DATE: February 17, 2026
TO: ALL CONTRACTORS
FROM: DUSTINE TILL
PROJECT: ROSCOE ROAD WATER TREATMENT PLANT
ORANGE BEACH WATER AUTHORITY
GMC PROJECT NO. CMOB230049
RE: ADDENDUM #3

ADDENDUM NUMBER 3

ROSCOE ROAD WATER TREATMENT PLANT

GMC PROJECT NO. CMOB230049

A-721

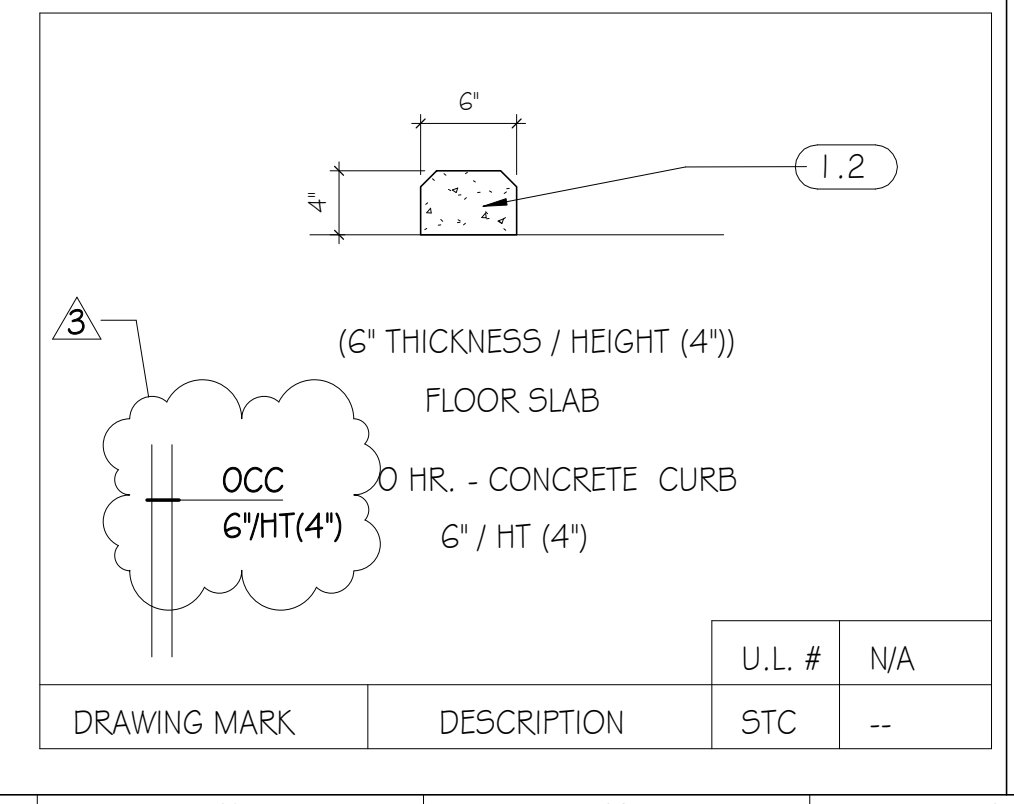
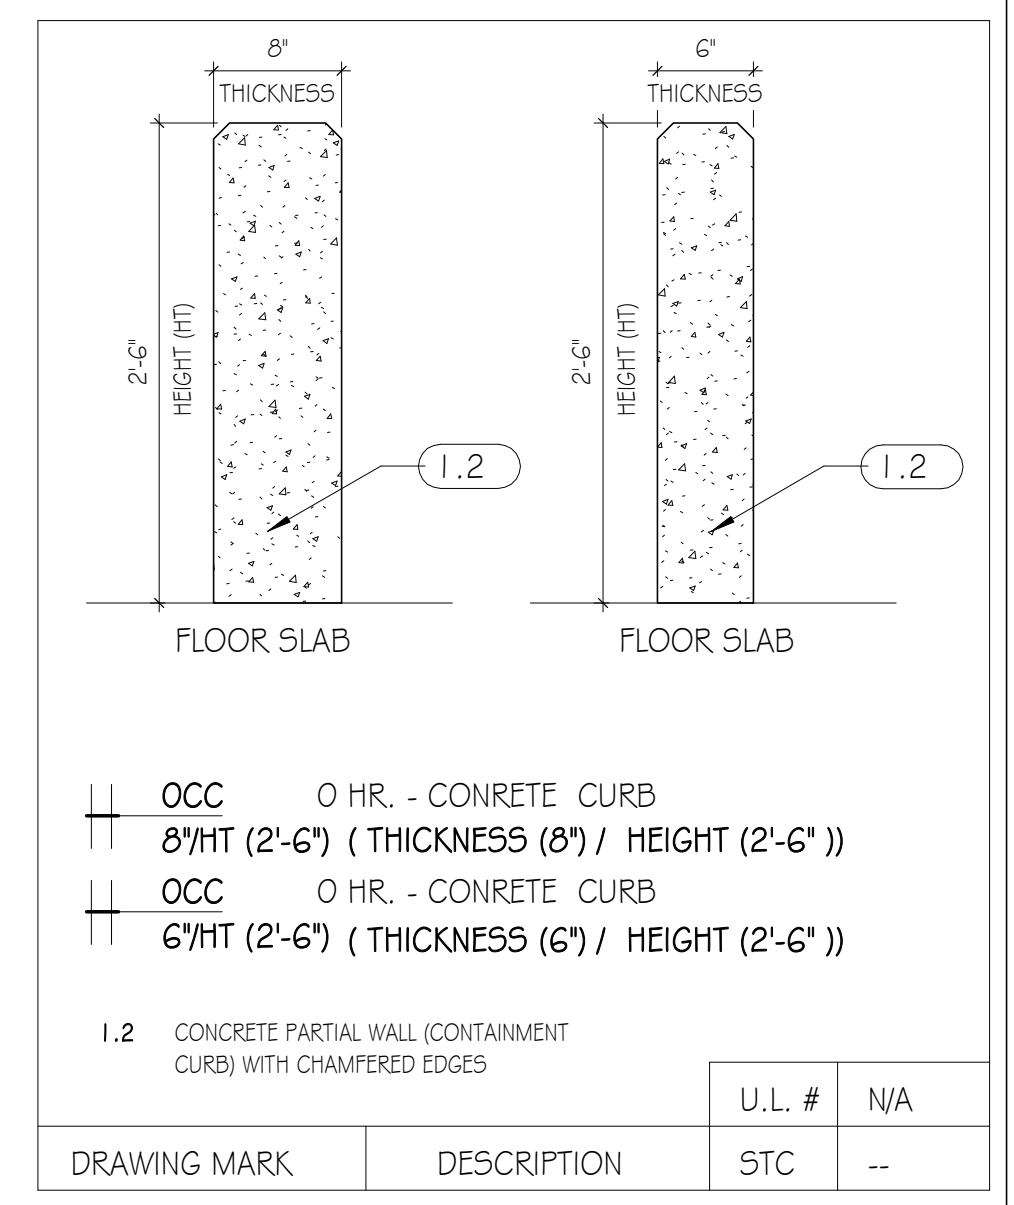
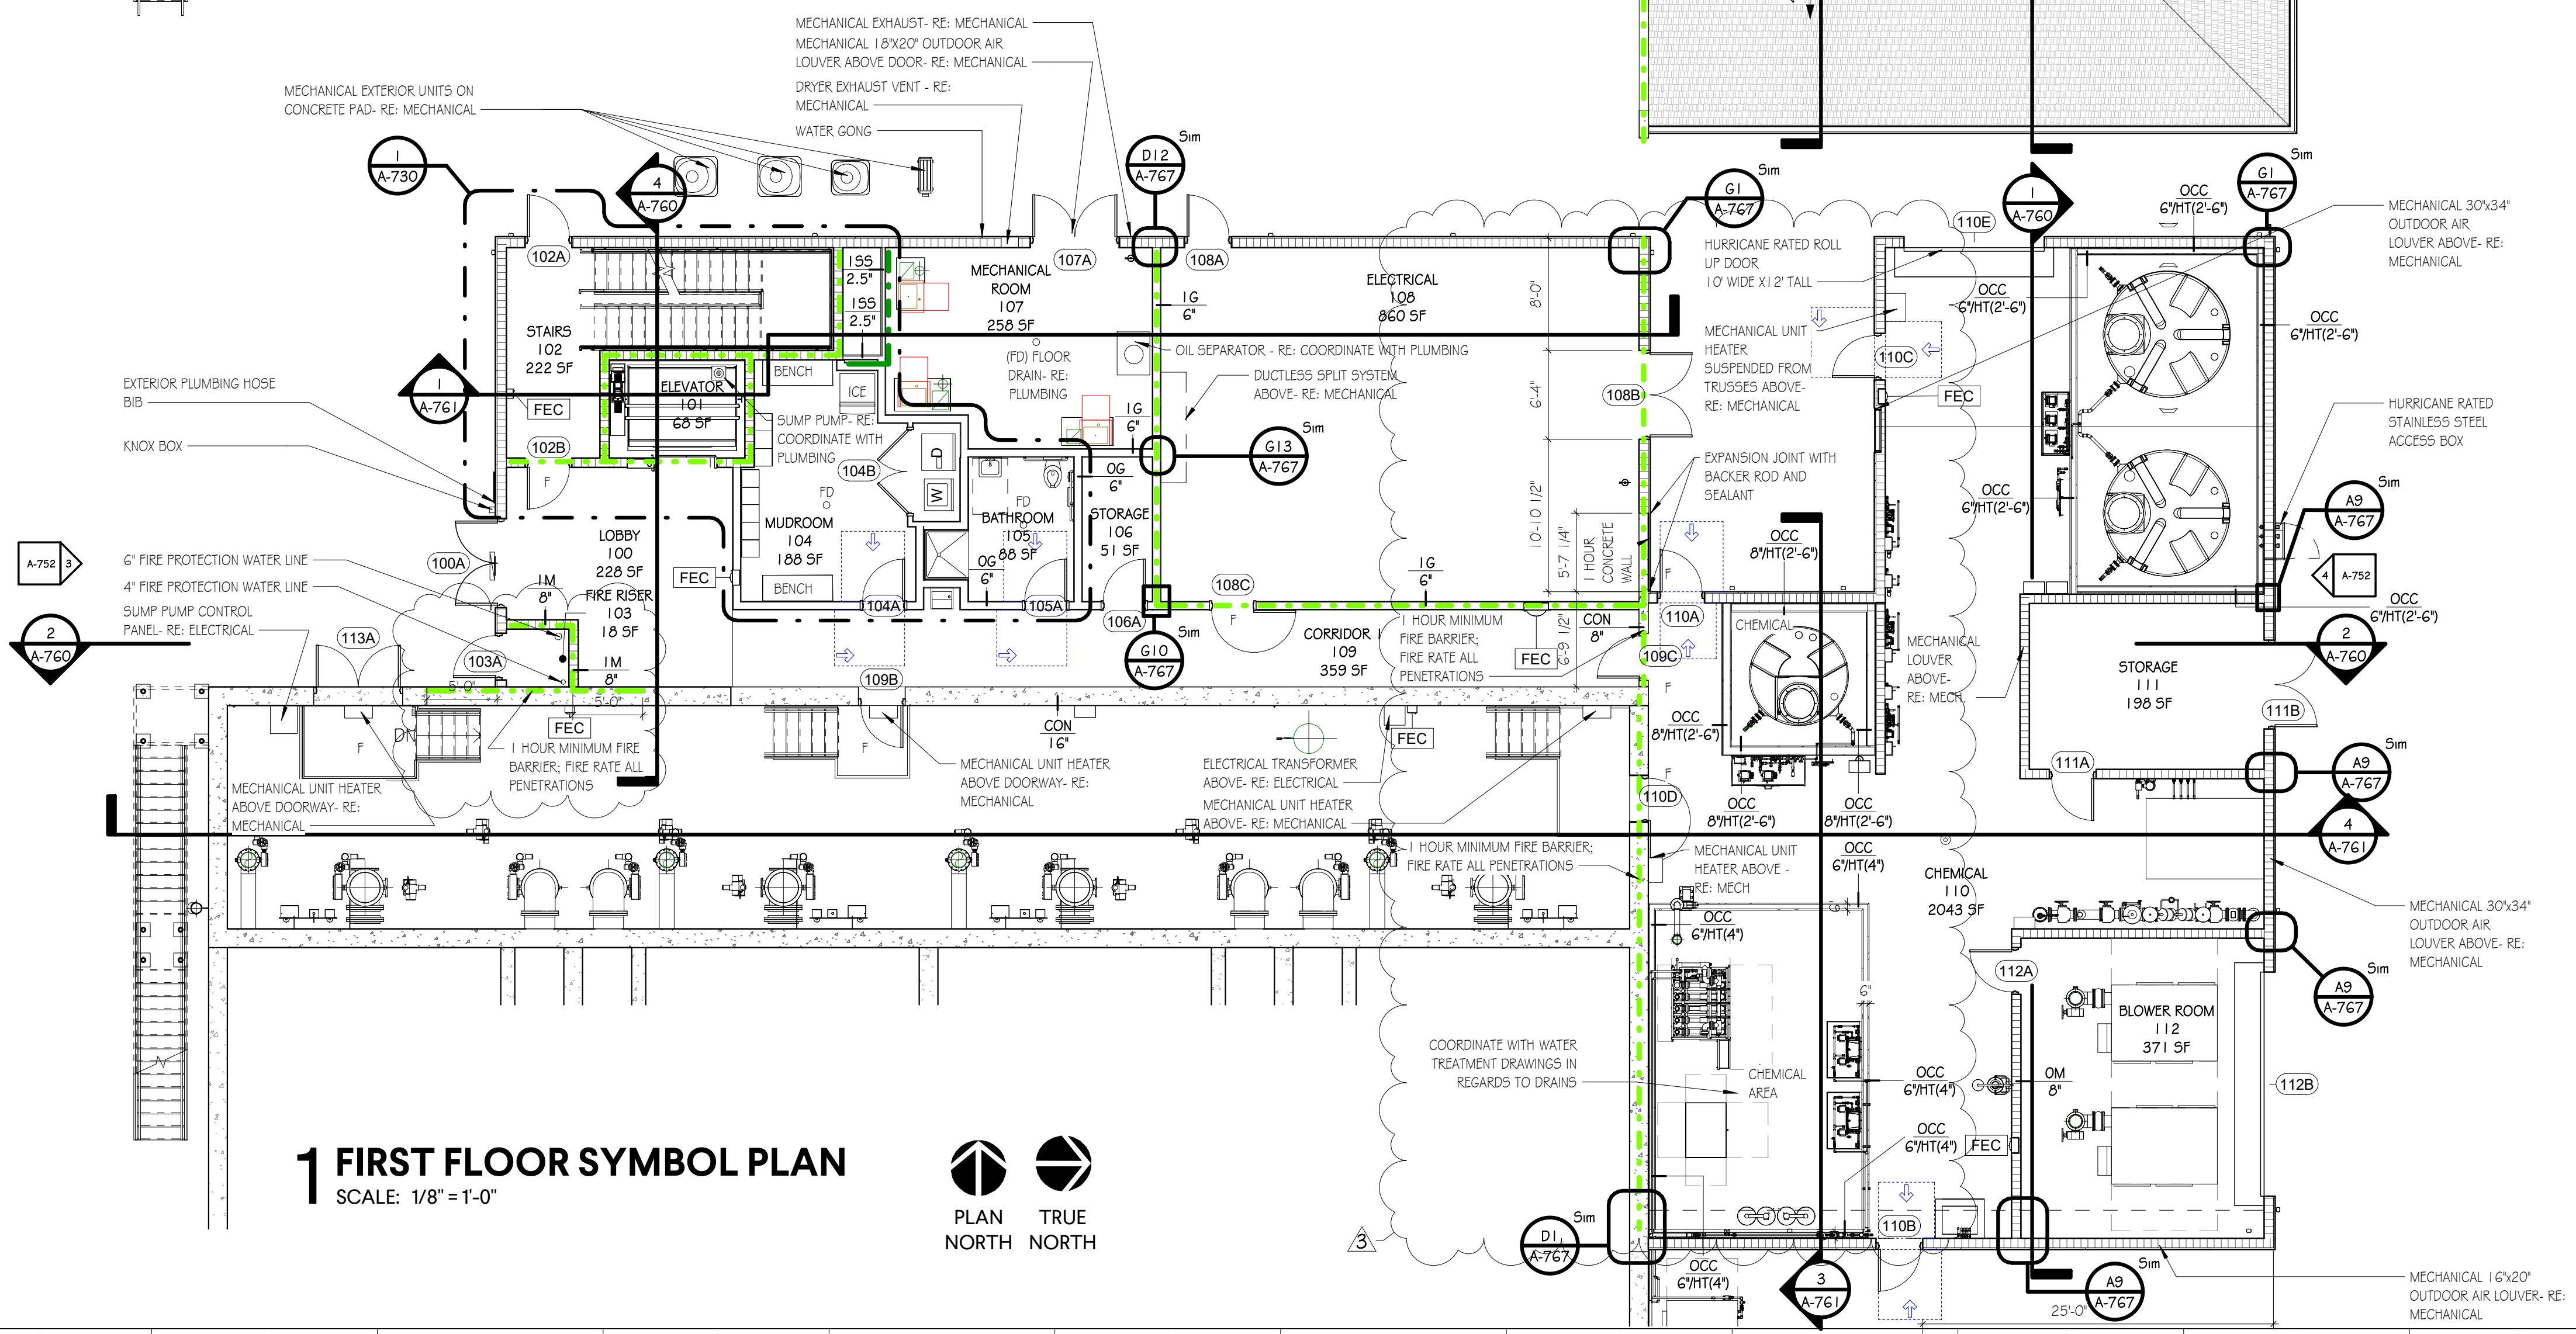
- 5.30 **Question: There appears to be a chemical trench with grating in the First Floor Chemical Area on A-721 that does not appear to be reflected in the Structural Slab on S-722. Please confirm and provide structural detail for the Trench.**

Answer: There is no trough in the floor in the hypo area. This was inadvertently left on the architectural drawings. There is a floor drain in this area.

Answer: They drain from the finish floor elevation. There is no trench in this area.
- 5.32 **Question: The Concrete Curb around the Chemical Area on A-721 appears to note the height as 2’-6”, the same curb on Drawing S-722 shows 0’-4”. Please clarify the width and curb height on the four sides of this area.**

Answer: The concrete curb around the Hypo area in the Chemical Building shall be 4” H x 6” W.
- 5.33 **Question: Are the Stairs/Landings at Doors 113A, 109B and 110D on Drawings A-721 and S-723 intended to be Steel Pan Stairs/Framed Platforms with Concrete Fill or Fabricated Aluminum Assemblies?**

A-771

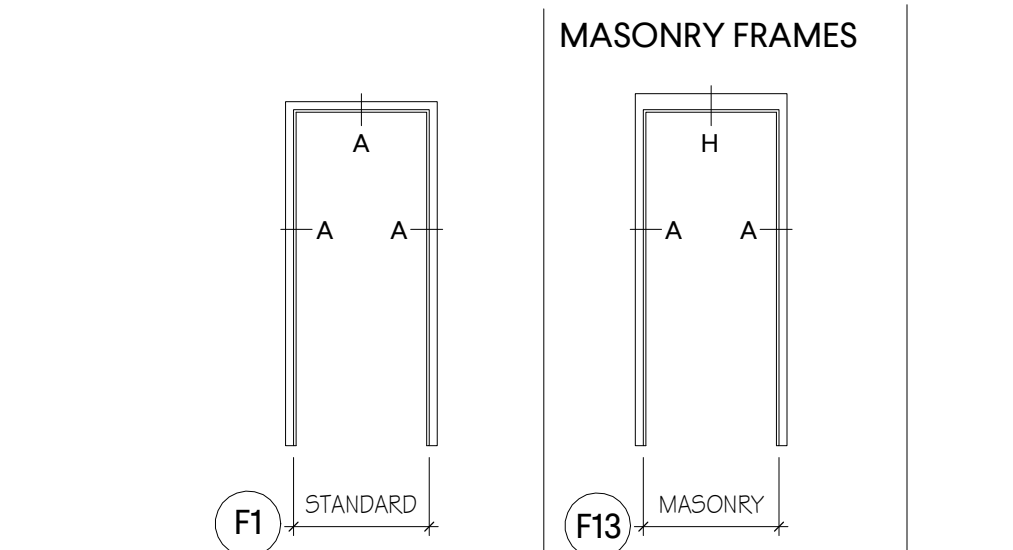
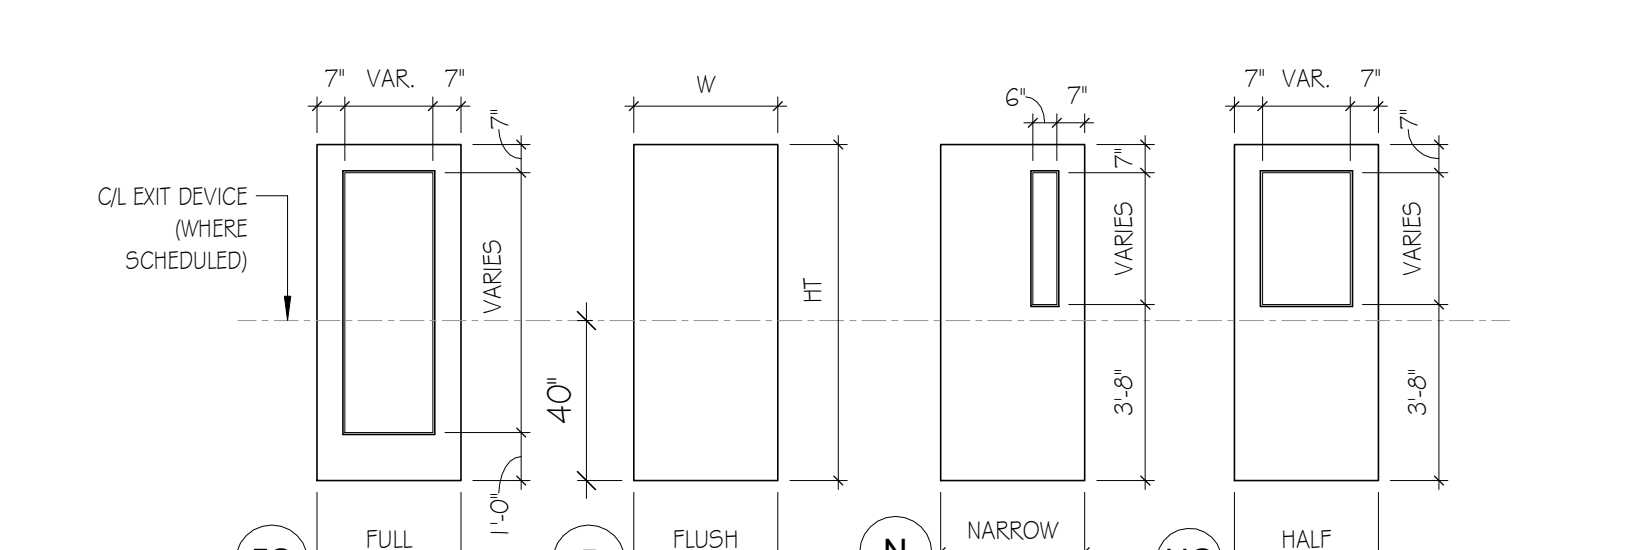
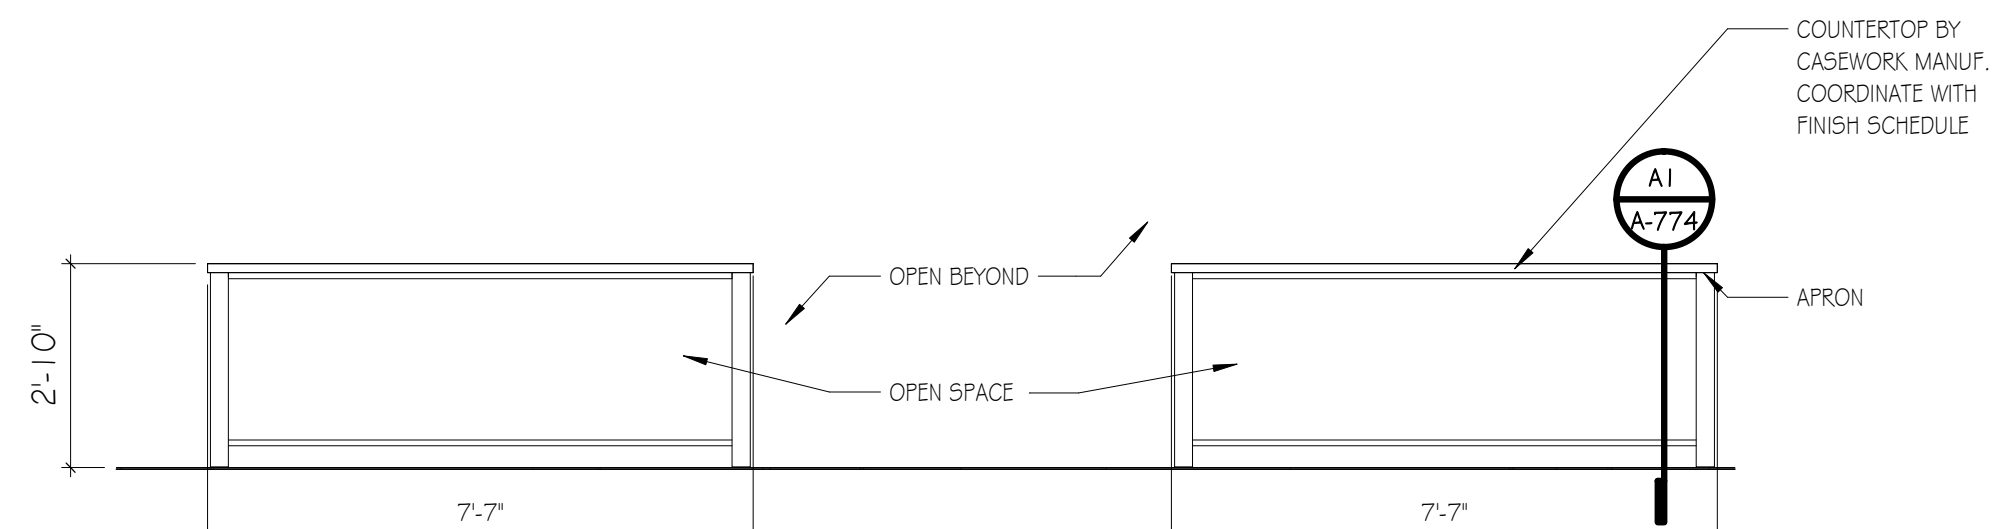
- 5.35 **Question: Doors 209A, 210A, 210B and 211A do not appear on the door schedule. Please add an include door size, type, material, glass if required, fire rating and hardware notes.**

Answer: Doors 209A, 210A, 210B and 211A have been added to Sheet A-771 and clouded. Revised Sheet A-771 – Door Schedule, Legend, & Notes has been included as an attachment of this addendum.
